DESIGN REVIEW COMMISSION AGENDA

1. Meat Shop, 7771 Highway 70 (Neeraj Kumar, Design Group LLC)

City of Bartlett, Tennessee Design Review Commission Staff Report

SUBJECT: Site Plan Application Review

DUMPSTER DETAIL

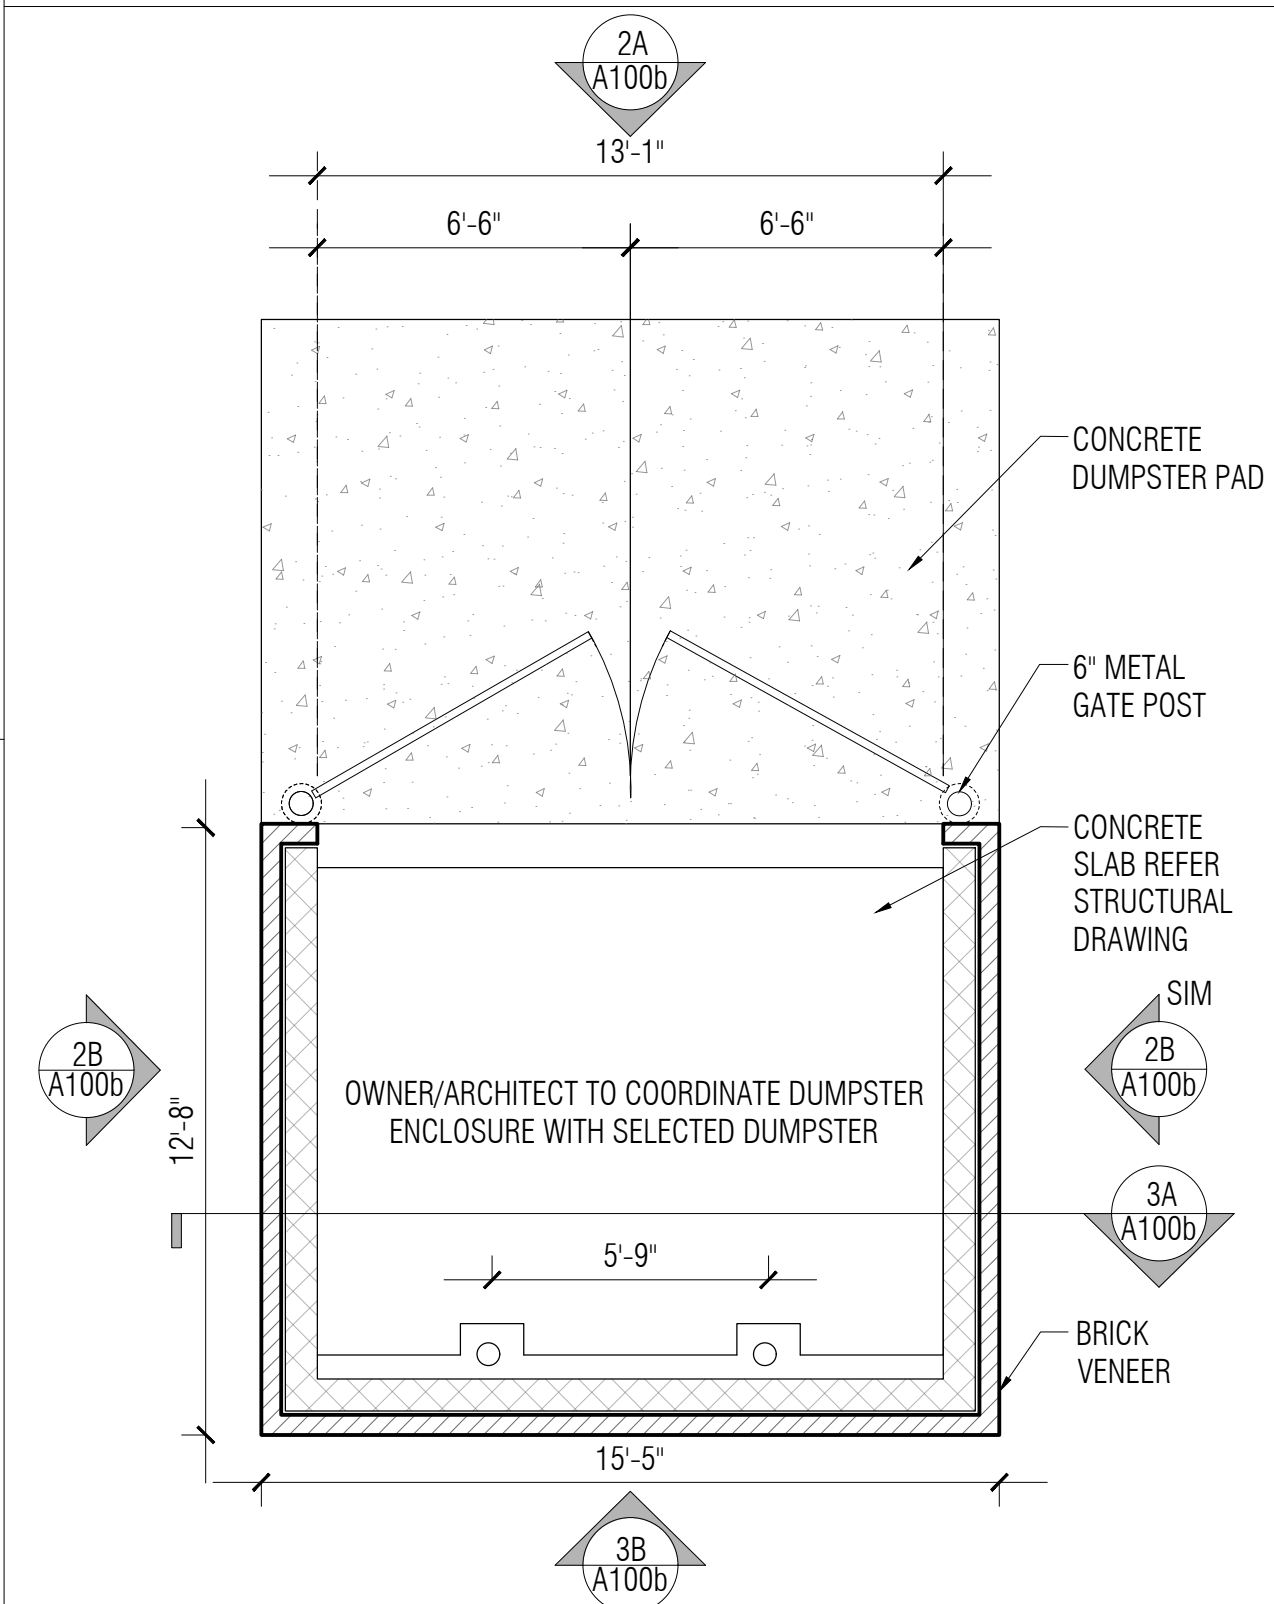
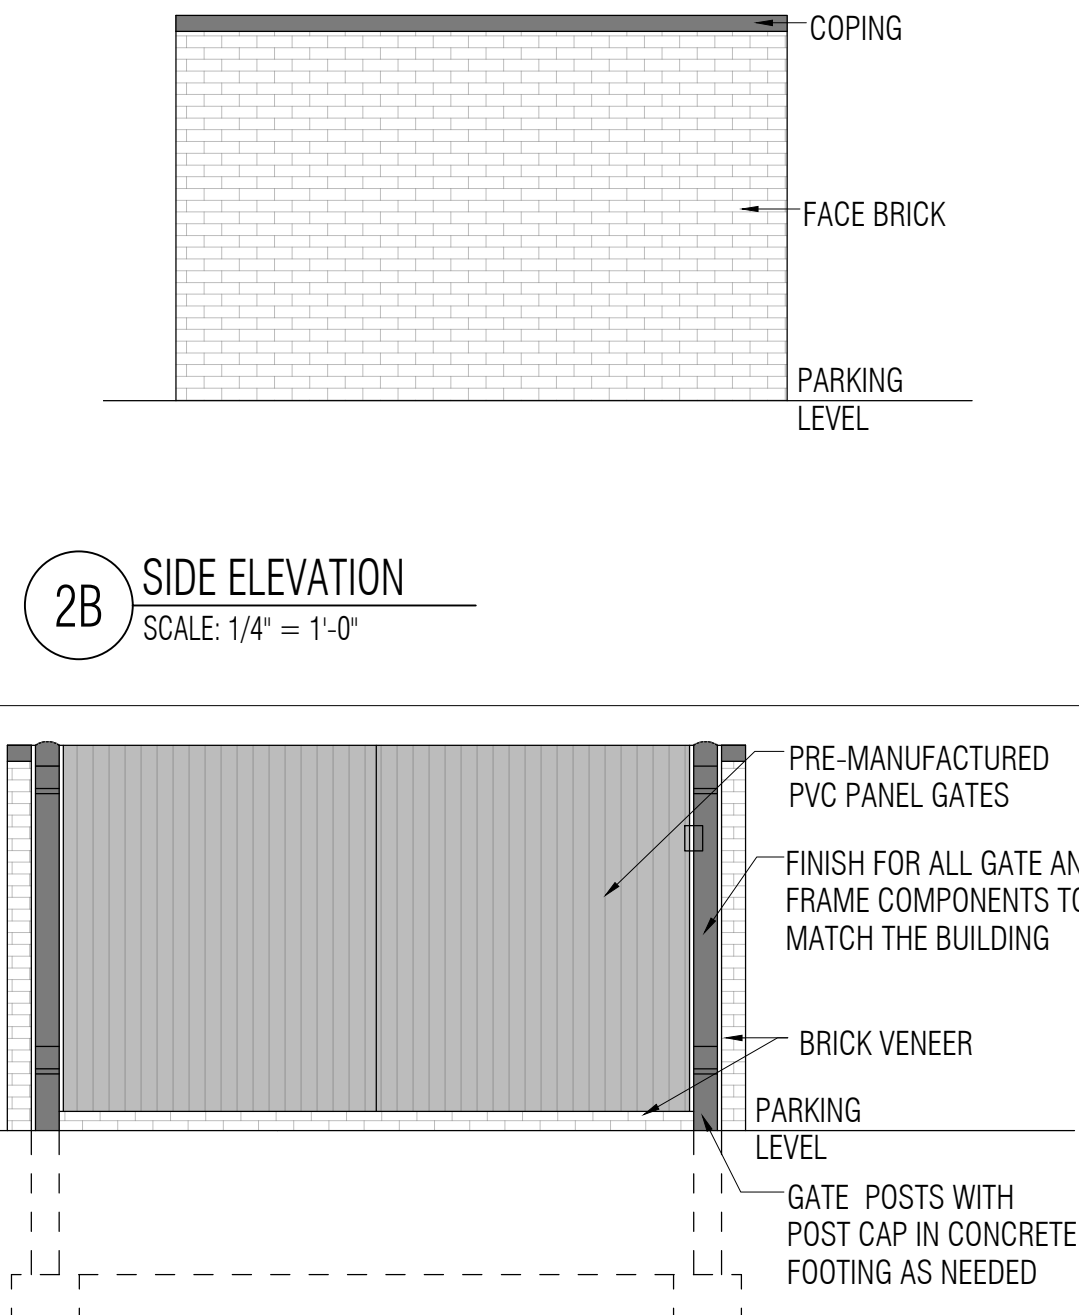
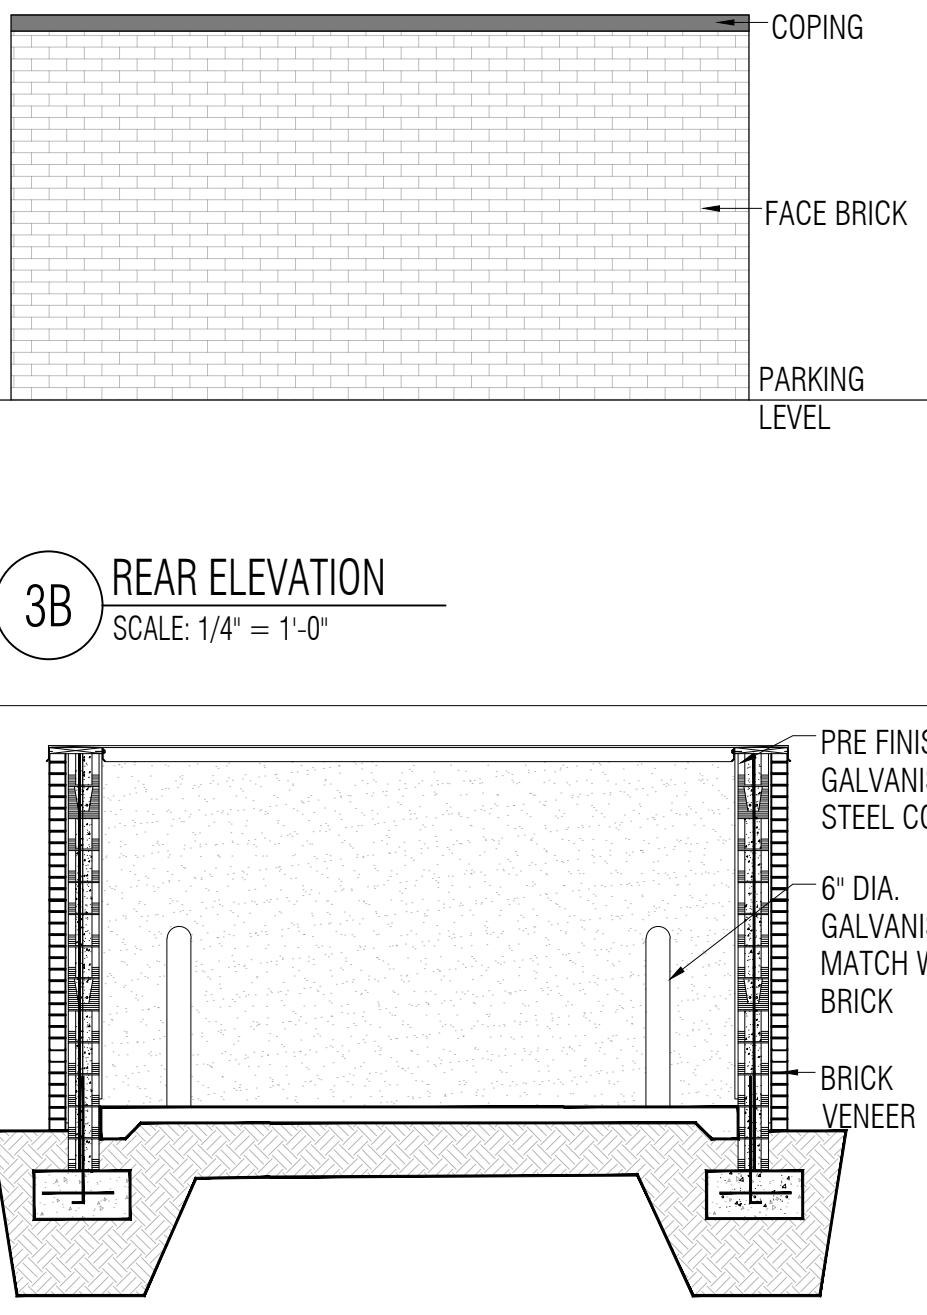
1. The applicant shall add Streetscape/Landscape Plate 23 A, B, or C template to the Site Plan along Highway 70 taking care to avoid the utility easement. Staff recommends utility friendly trees due to the power lines at the street.
2. The applicant shall add steel drop pins to the dumpster enclosure gates.

DRAWING NAME
SITE PHOTOMETRIC
PLAN

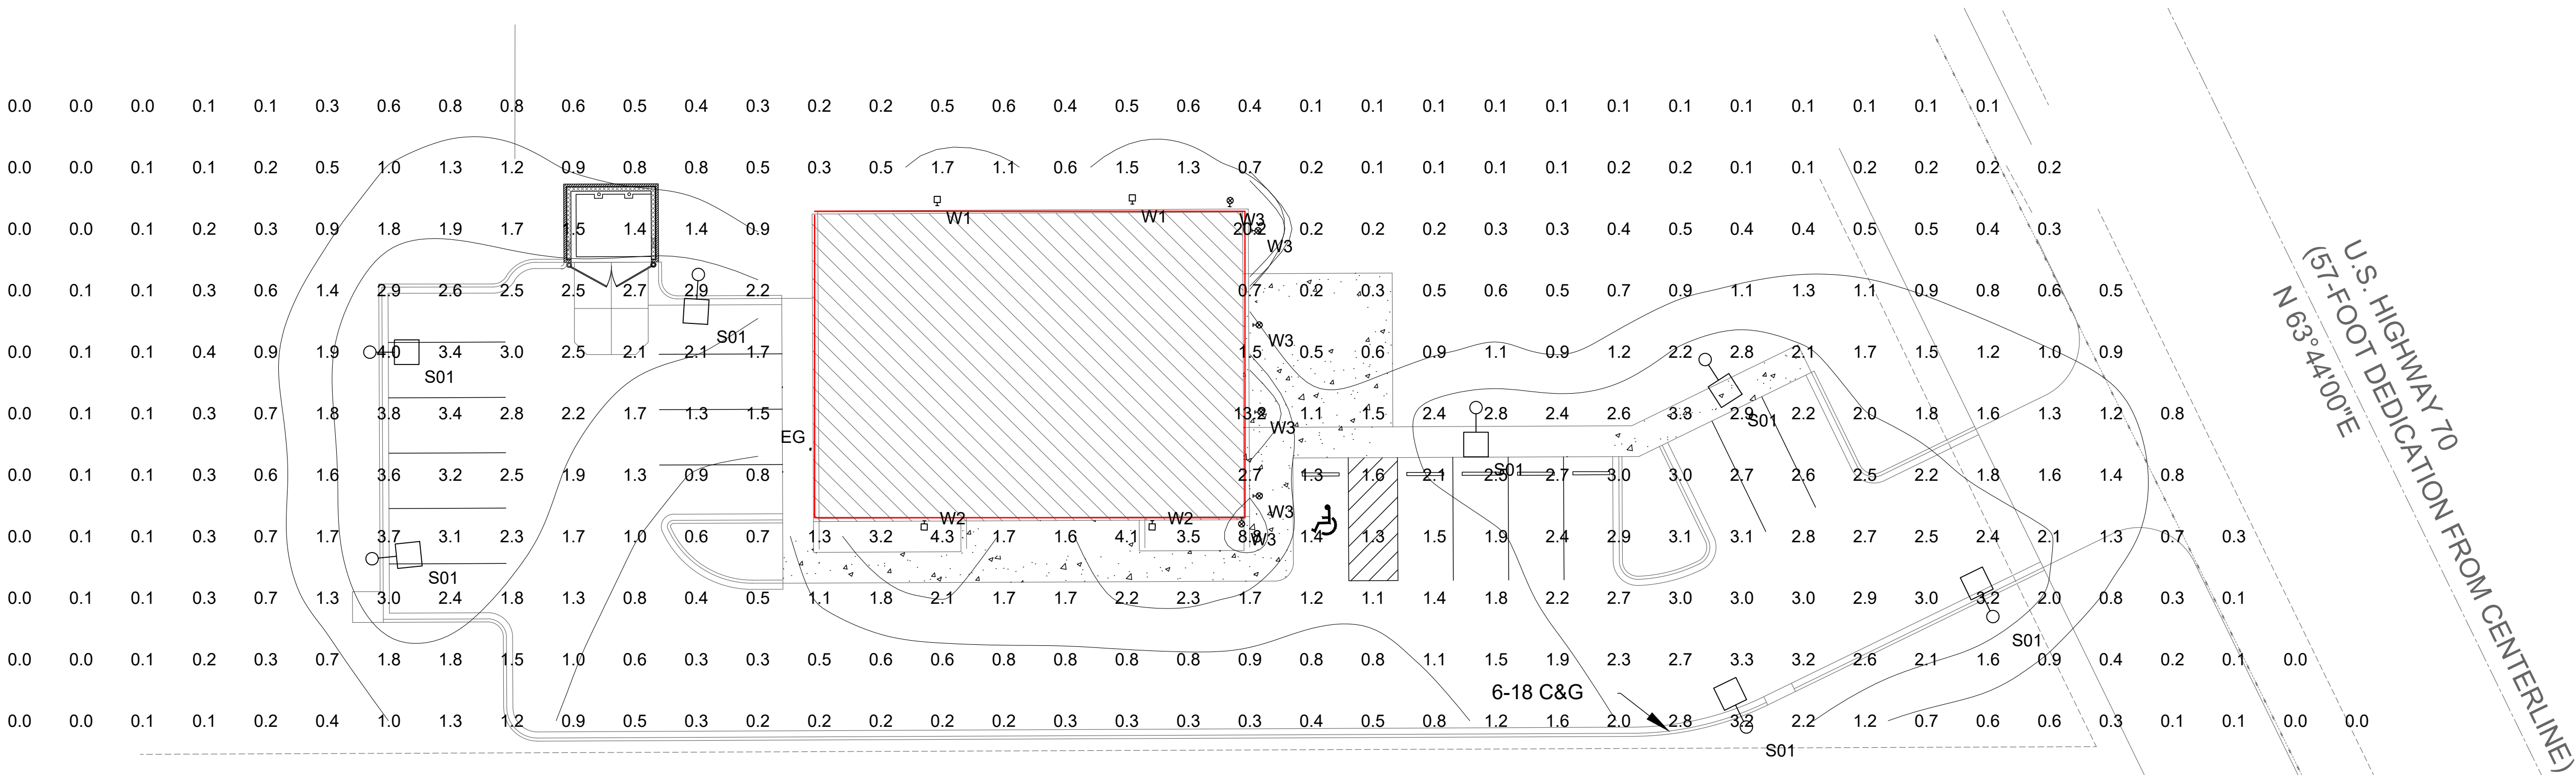
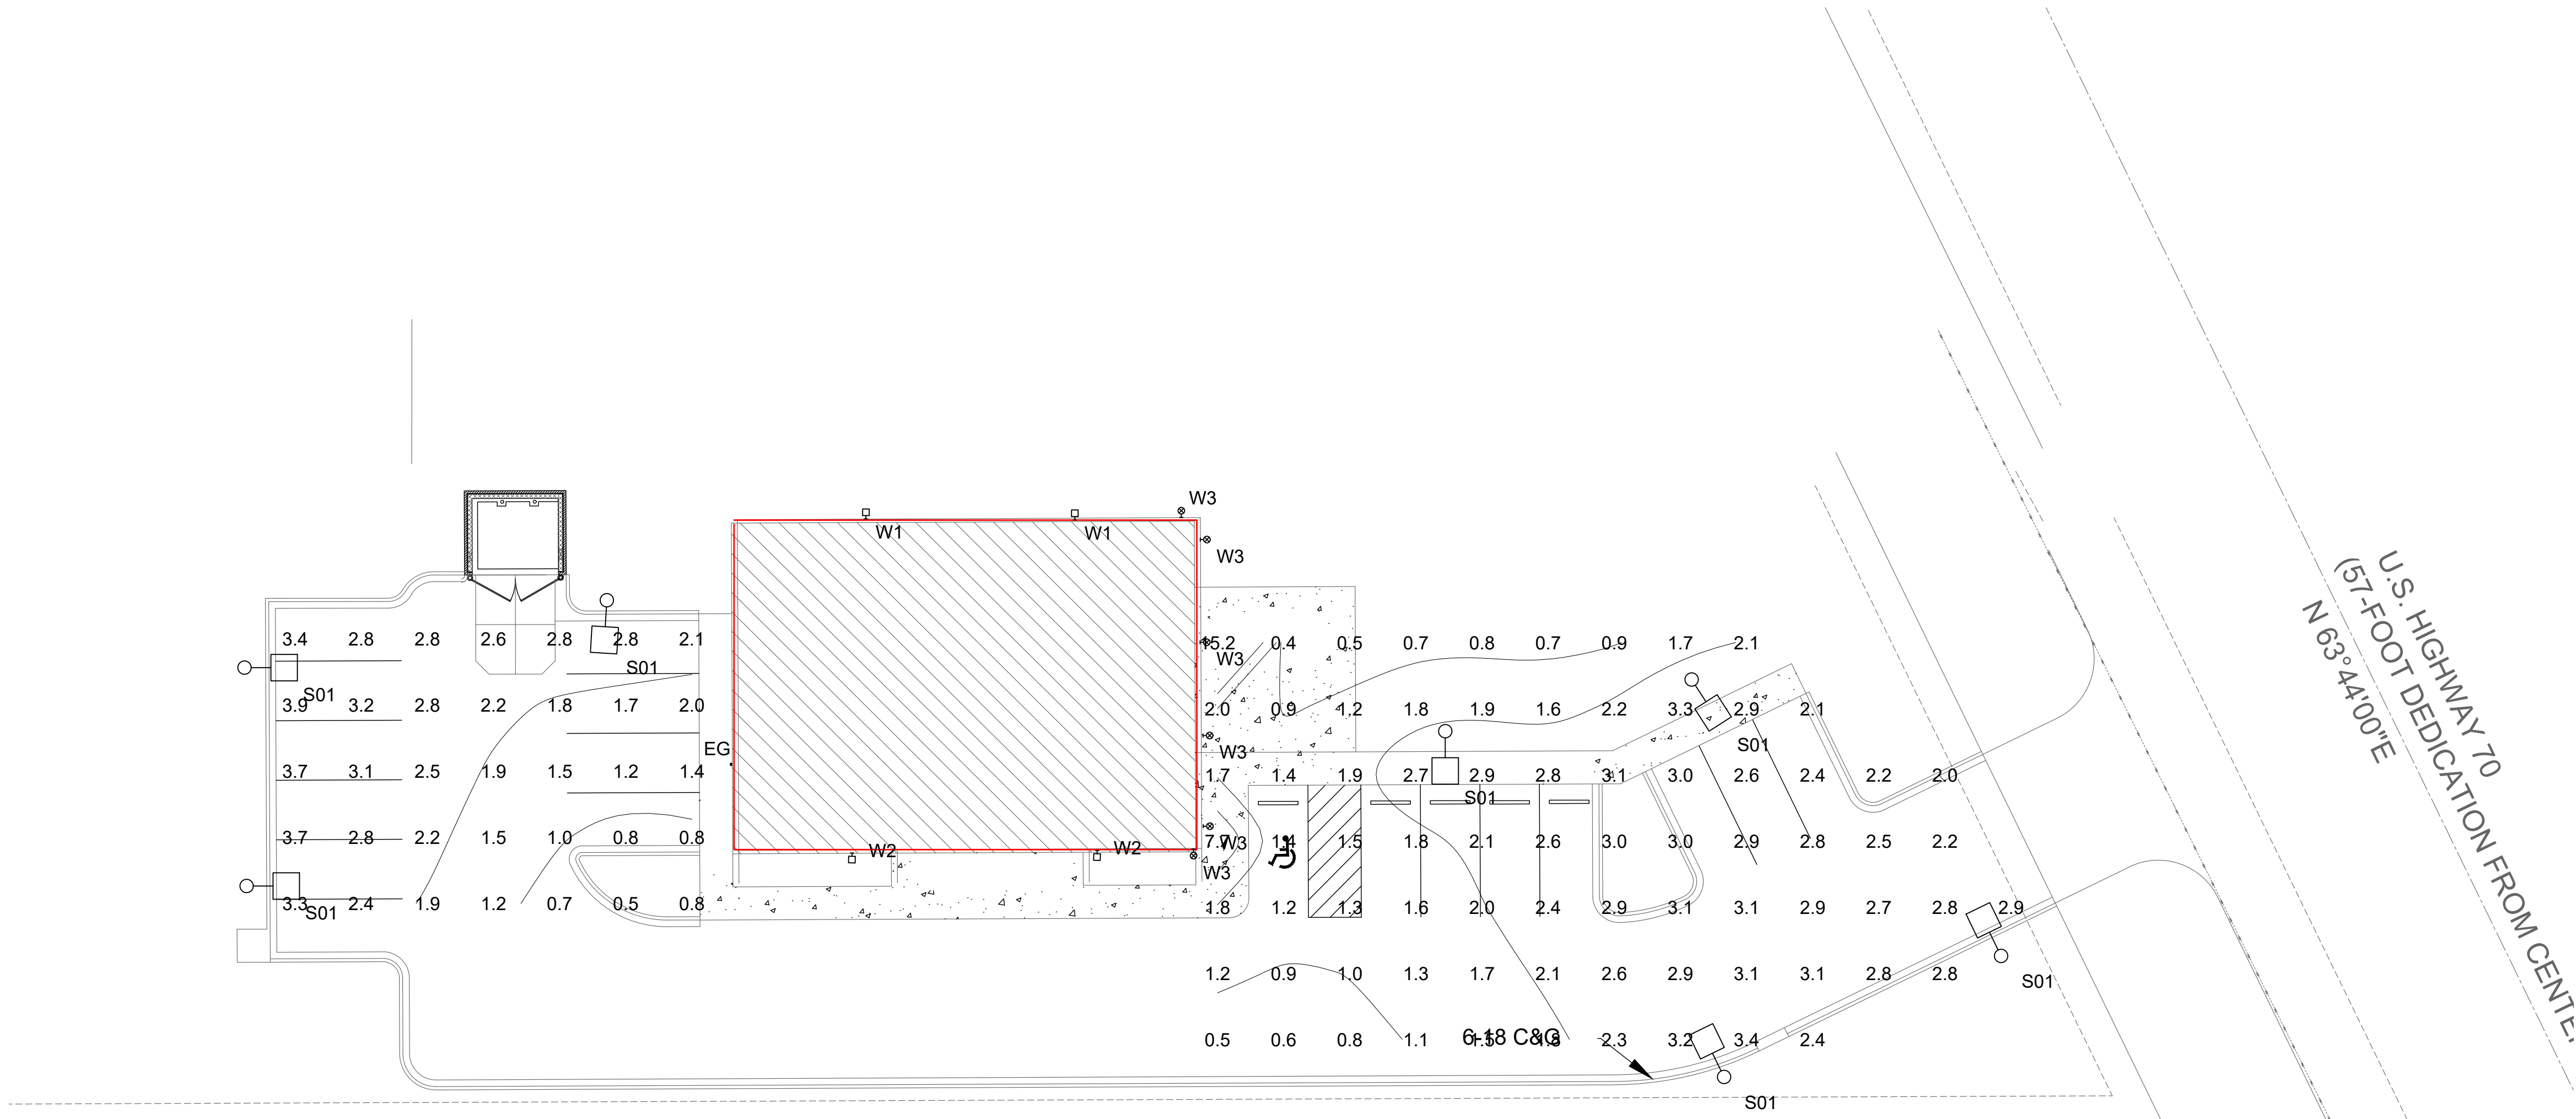
1. The applicant states the base will be 2 feet from grade. Combined with the 16 foot pole and fixture will yield a maximum fixture height of 18.5 feet.

3. The applicant shall replace the 6.5K LED emergency light with 4K LED emergency light.
4. The applicant shall provide a light pole detail diagram for all six proposed light pole fixtures, which shall include base, pole, and fixture. The maximum height for the proposed light pole, base and fixtures shall not exceed 25 feet in height from the top of grade.
